From: Buchan Rum Architects <info@buchanrumarchitects.co.uk>
Sent: 24 August 2023 15:01
To: Andy Watt
Cc: Emma Buchan; Emily Hatton
Subject: RE: DM/23/0140 - 68-70 Church Walk, Burgess Hill RH15 9AS
Attachments: M&Co - PL_100_00 06.pdf; M&Co - PL_101_00 06.pdf; M&Co - PL_102_00 04.pdf; M&Co - PL_103_00 04.pdf; M&Co - PL_104_00 03.pdf; M&Co - PL_105_00 01.pdf; M&Co - PL_106_00 01.pdf; M&Co - PL_107_00 01.pdf; M&Co - PL_108_00 01.pdf; M&Co - PL_400_00 04.pdf; M&Co - PL_401_00 04.pdf; M&Co - PL_500_00 04.pdf; M&Co - PL_501_00 04.pdf

Re: DM/23/0140 – 68-70 Church Walk, Burgess Hill. RH15 9AS

Description: redevelopment of an existing 2 storey commercial building to create four storey mixed use building. Through the addition of new floors over the existing building footprint (with partial demolition of the existing 1st floor) to accommodate 10 no of flats over the top three floors retaining the existing commercial/retail use of ground floor

1:50	A1	
Date	Dn By	
06/2023	BRA	
Drawing number:	Rev.	
PL_500_00	04

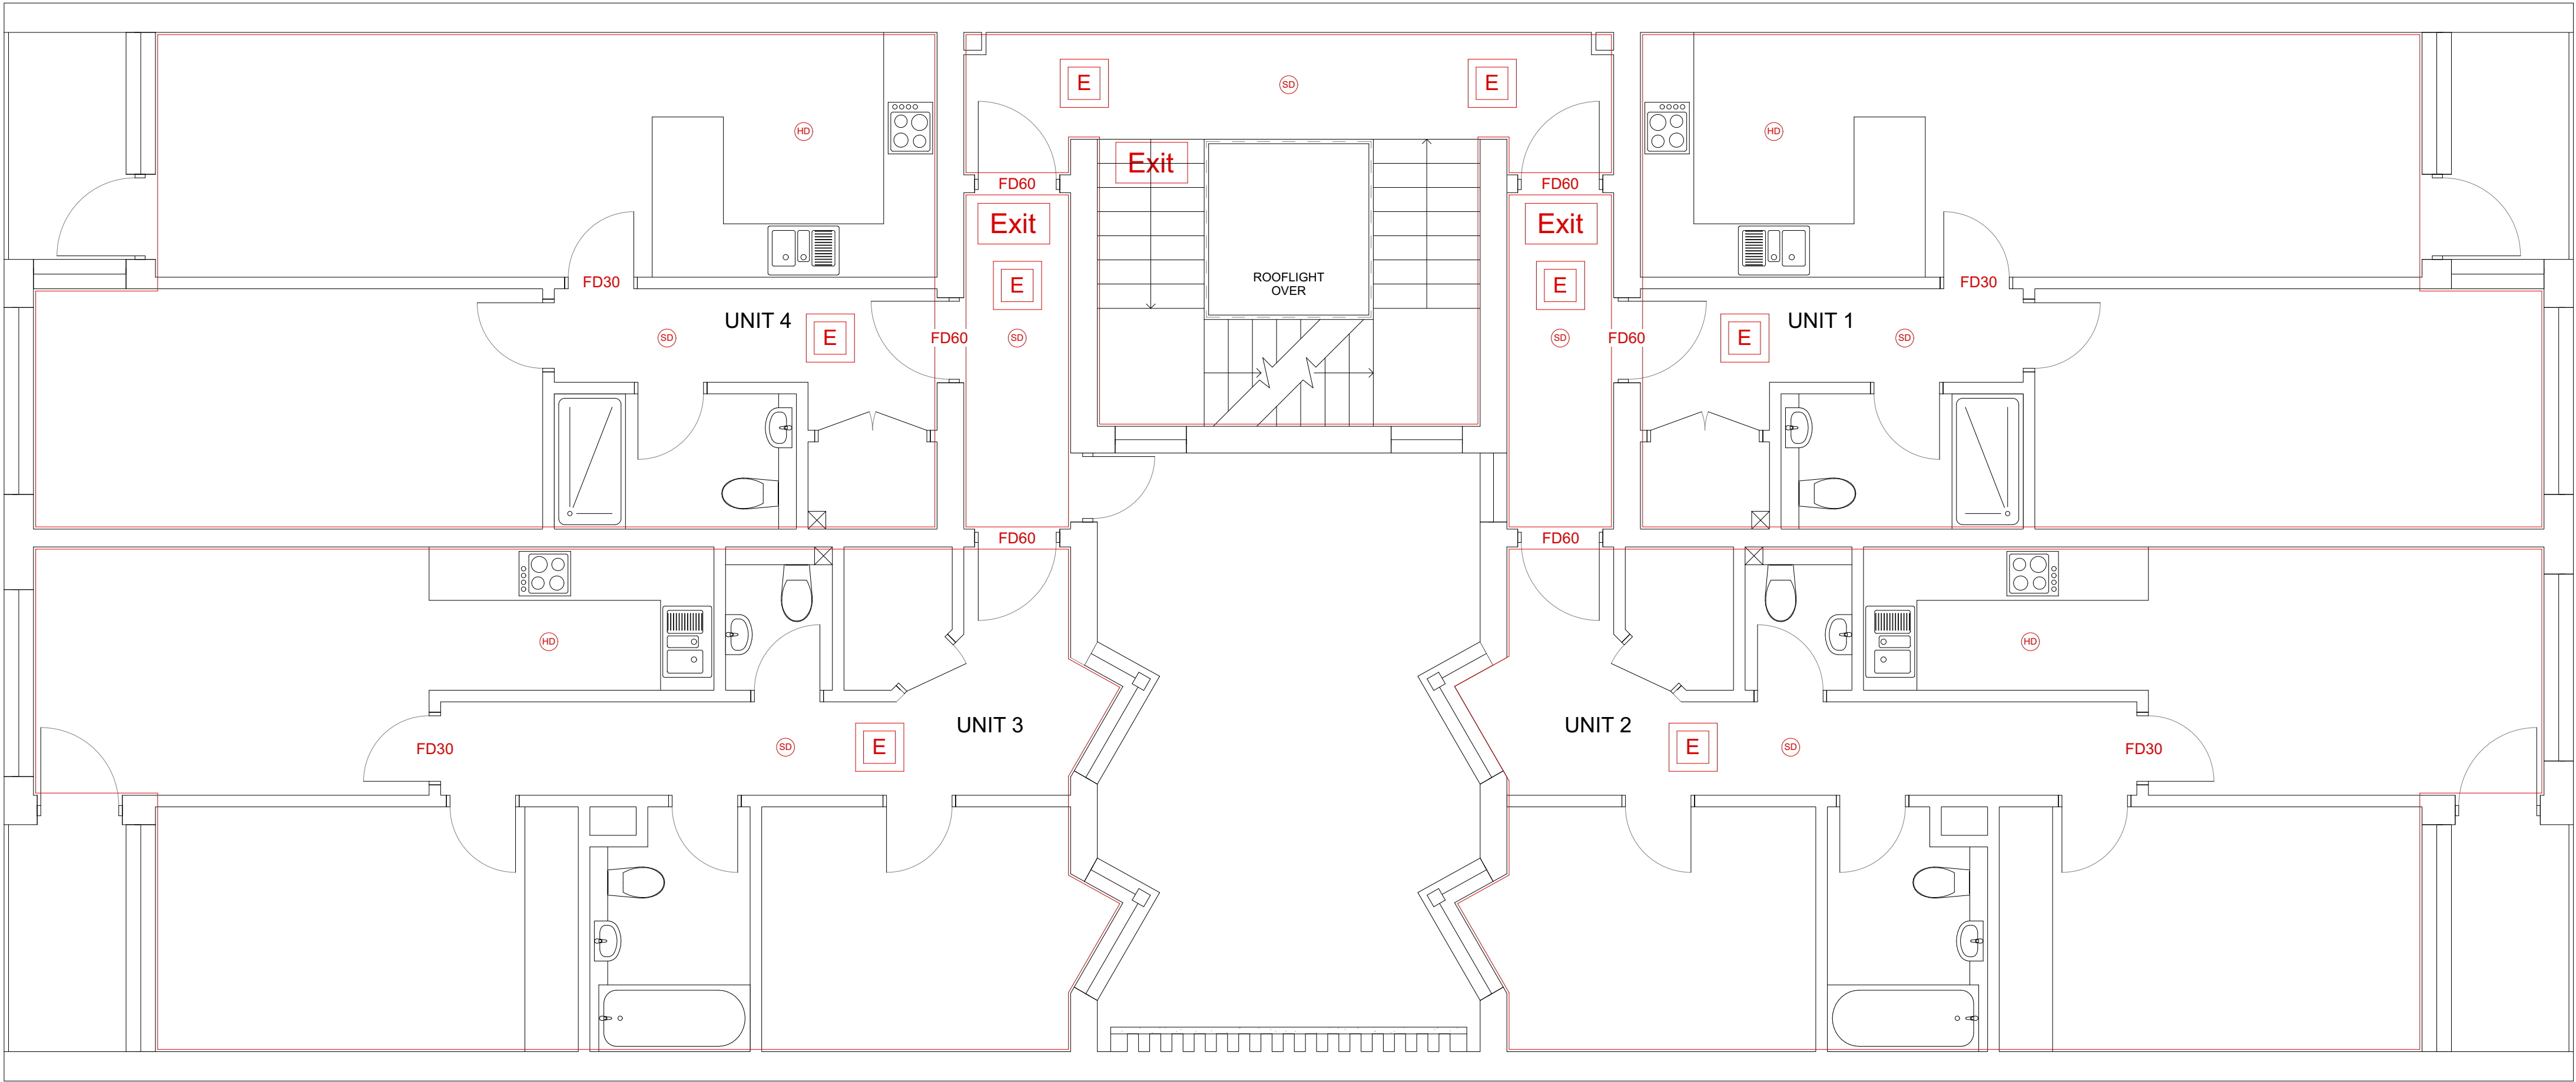
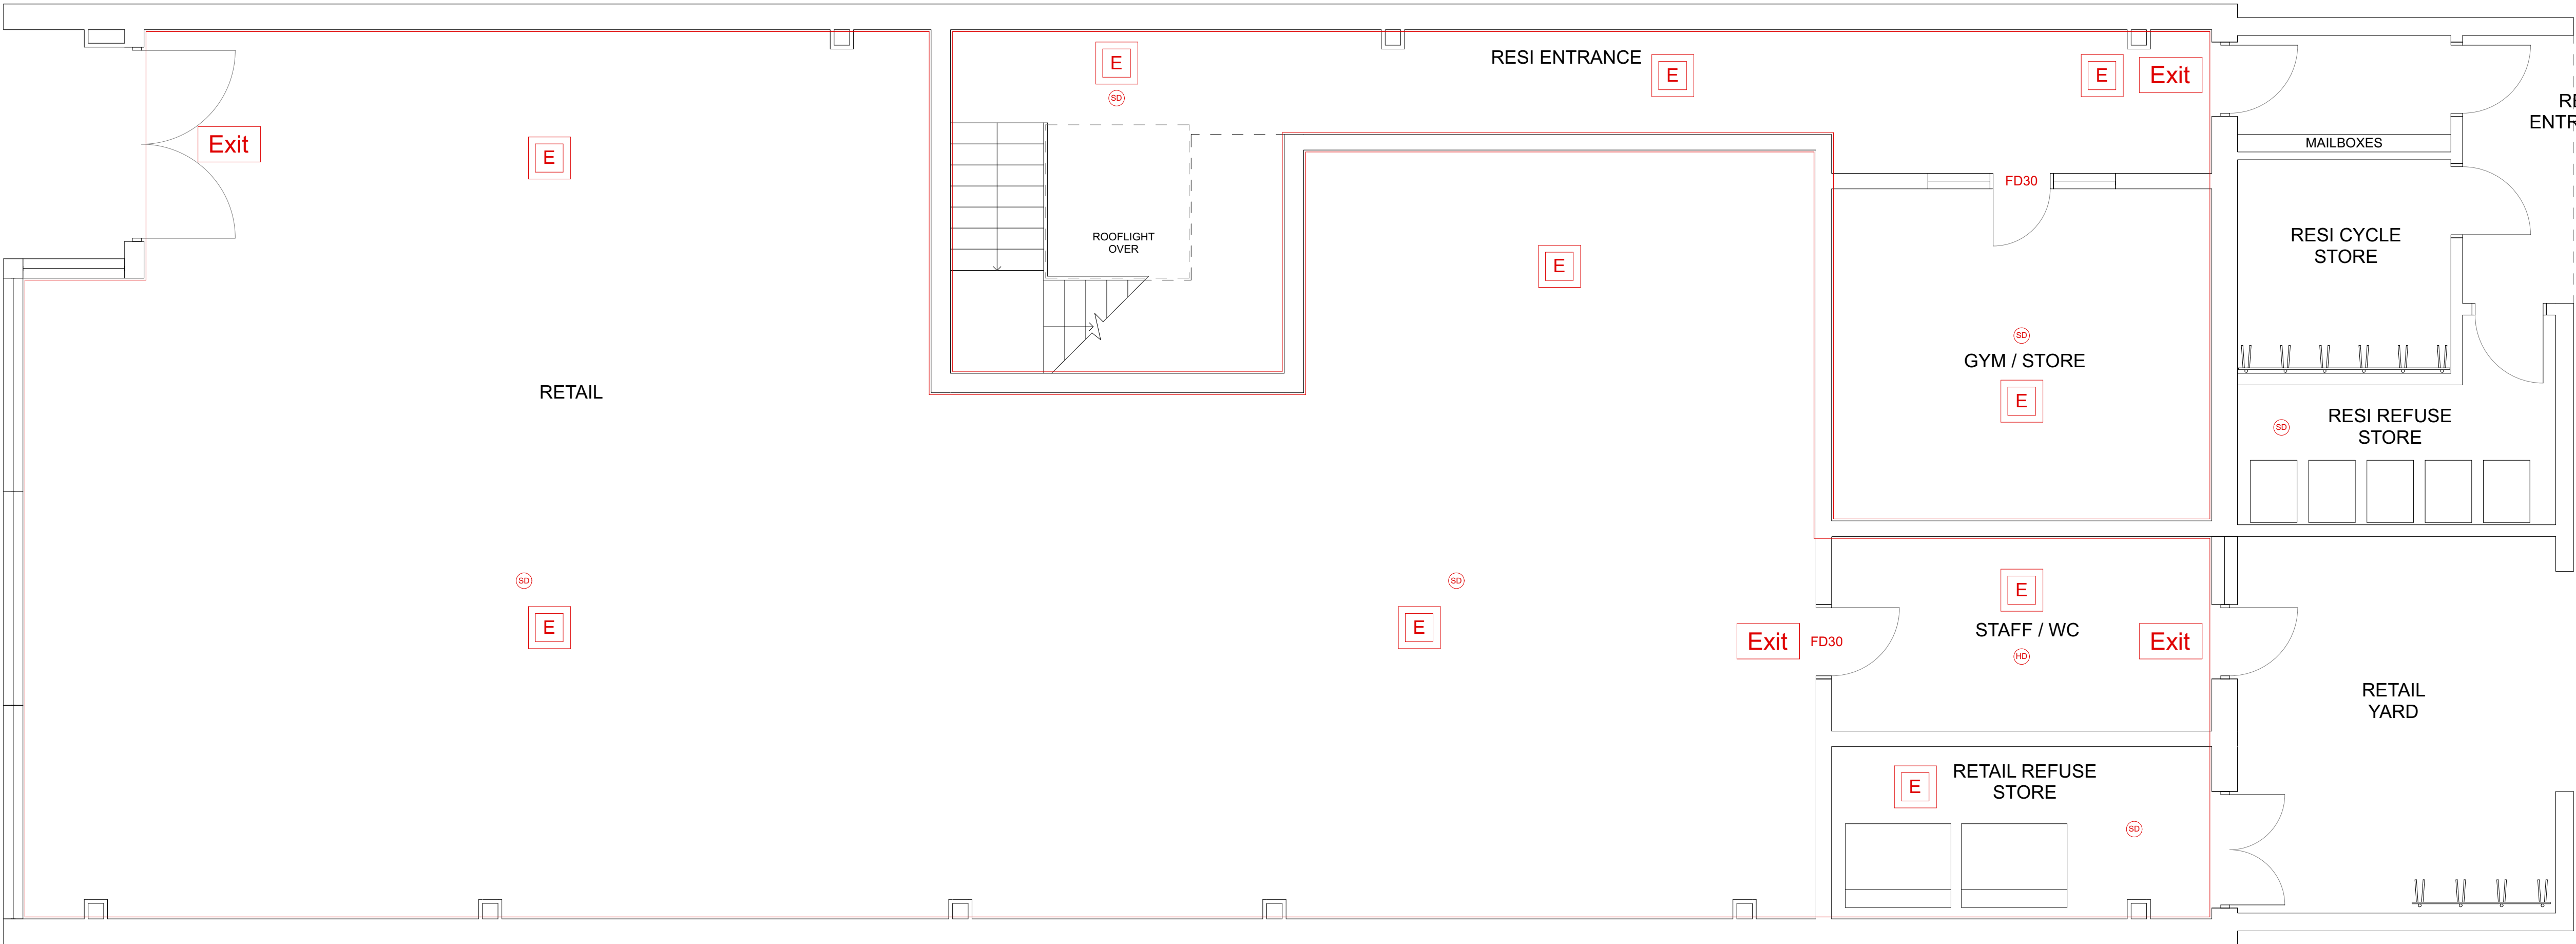
5. Means of escape in case of fire. Provision of 30 Minute fire doors to kitchen and living areas.
6. Interlinked early fire alarm system to whole building with a 30 minute warning system.
7. Suitable and sufficient fire protection and means of escape must be provided including fire doors and interlinked fire alarm systems where appropriate. Escape routes should avoid travel through high risk rooms, namely, bedrooms accessing out of the accommodation past open plan kitchens.
8. Liaison with the Fire And Rescue Service may be appropriate to ensure the fire safety in place links with all the flats. Also to ensure there is sufficient fire protection between the commercial units and the residential above.
9. Balconies require a 60 minute fire protection.

1. Fire doors to kitchen and living areas – 30 minute fire doors shown.
2. To confirm an interlinked early fire alarm system to whole building with a 30 minute warning system will be installed.
3. Escape routes do not travel through high risk rooms.
4. All materials used on balconies will have a 60 minute fire protection
